Access Compliance Report

Public Rights-of-Way

(Curb Ramps)

Intersection ID: N/A	Main Street: BLYTHNE_BV	Cross Street: N/A	Location: SE
ADA ID: BB819E86141A	Ramp Type: Perp	Initial Pass/Fail: Fail	Overall Compliance: No
Severity Score: 1.25			
Codes/Mitigation Info/Possible Solution		Field Measurements/Component Compliance

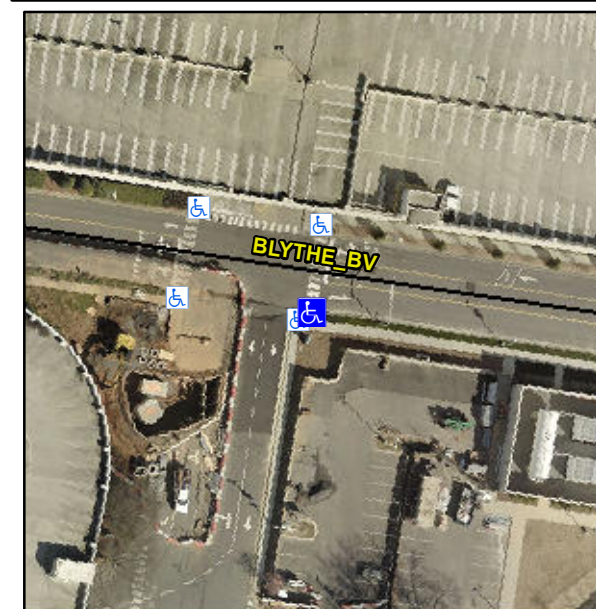
Not Found, R304.5.3

Compliance	Description	Data	Compliance	Description	Data
N/A	Ramp Length (in)	42.0	Yes	Ramp Slope (%)	5.5
Yes	Ramp Width (in)	48.0	No	Ramp XSlope (%)	2.8
N/A	Flare Type LT	N/A	N/A	Flare Type RT	N/A
N/A	Flare Slope LT (%)	N/A	N/A	Flare Slope RT (%)	N/A
N/A	Flare Traversable LT?	N/A	N/A	Flare Traversable RT?	N/A
N/A	Landing Length (in)	N/A	N/A	DWS Provided?	N/A
N/A	Landing Width (in)	N/A	N/A	DWS Contrast?	N/A
N/A	Landing Slope (%)	N/A	N/A	DWS Length (in)	N/A
N/A	Landing X Slope (%)	N/A	N/A	DWS Full Width?	N/A
N/A	Landing Curb? (Y/N)	N/A	N/A	DWS Offset (in)	N/A
N/A	Shared Landing?	N/A			
N/A	Gutter Ponding?	N/A	N/A	Gutter Slope (%)	N/A
N/A	Gutter Lip Ht (in)	N/A	N/A	Gutter X Slope (%)	N/A
N/A	Painted X Walk1?	Yes	N/A	Painted X Walk2?	N/A
	X Walk 1 Direction	To NE		X Walk 2 Direction	N/A
N/A	X Walk 1 Width (in)	74.0	N/A	X Walk 2 Width (in)	N/A
	X Walk 1 Slope (%)	3.6		X Walk 2 Slope (%)	N/A
	X Walk 1 X Slope (%)	0.8		X Walk 2 X Slope (%)	N/A

Remove & Replace Entire Ramp.
